CITY OF BOULDER
PLANNING BOARD MEETING AGENDA
DATE: August 18, 2016
TIME: 6 p.m.
PLACE: 1777 Broadway, Council Chambers

AGENDA TITLE: CONCEPT PLAN & REVIEW - Redevelopment of the existing seven-acre apartment site located at 1550 Eisenhower Drive with a new three-story apartment complex Eastpointe Apartment Homes, consisting of 236 proposed units in five buildings with below grade parking and on-site recreational amenities under case review no. LUR2016-00043.

SUMMARY:	CONCEPT PLAN & REVIEW – Proposal for five new three-story apartment buildings, a fitness building and associated site amenities with below grade parking. A total of 236 apartment units are proposed where 140 units exist today.
Project Name:	Eastpointe Apartment Homes
Location:	1550 Eisenhower Drive
Size of Tract:	Seven acres
Zoning:	Residential – High 4 (RH-4)
Comprehensive Plan:	High Density Residential
Key Issues:	Staff has identified three key issues for consideration: • Consistency with the BVCP (per Concept Plan Review Criteria); • Concept Plan responsiveness to existing context

Building Design (Elaine McLaughlin, 303-441-4130)

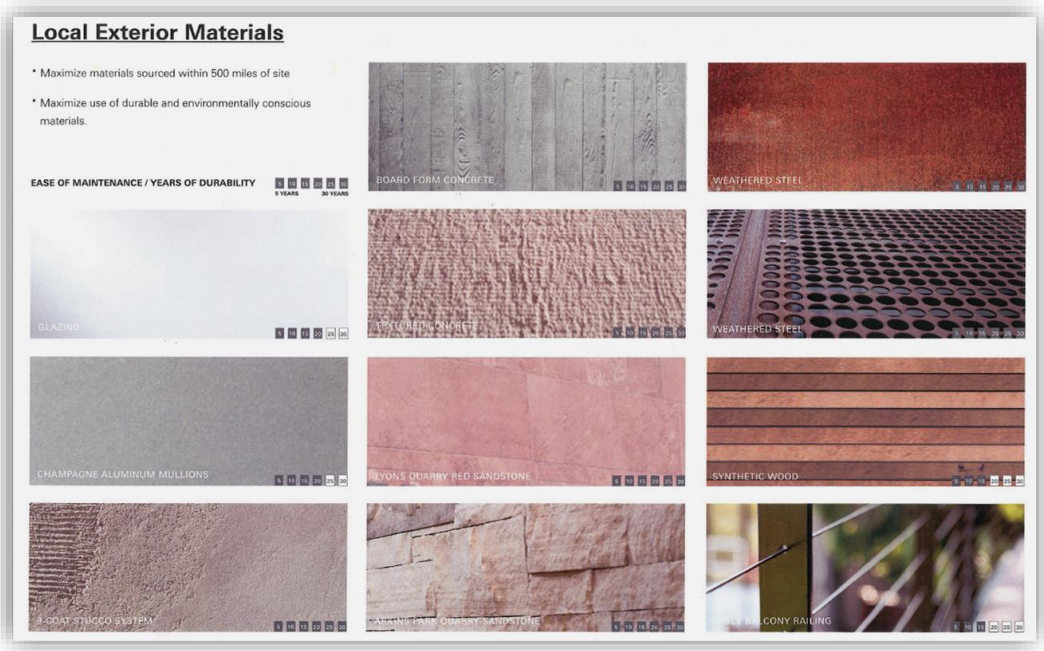
1. While early in the planning process, the applicant provided a strong palette of materials. As project plans progress, the applicant should reference the Site Review criterion (9-2-14(H)(2)(F)(xii) that requires, "*Exteriors of buildings present a sense of permanence through the use of authentic materials such as stone, brick, wood, metal or similar products and building material detailing.*" While most of the palette appears to address this criterion, the applicant should consider less use of "stucco" as a primary finish material.
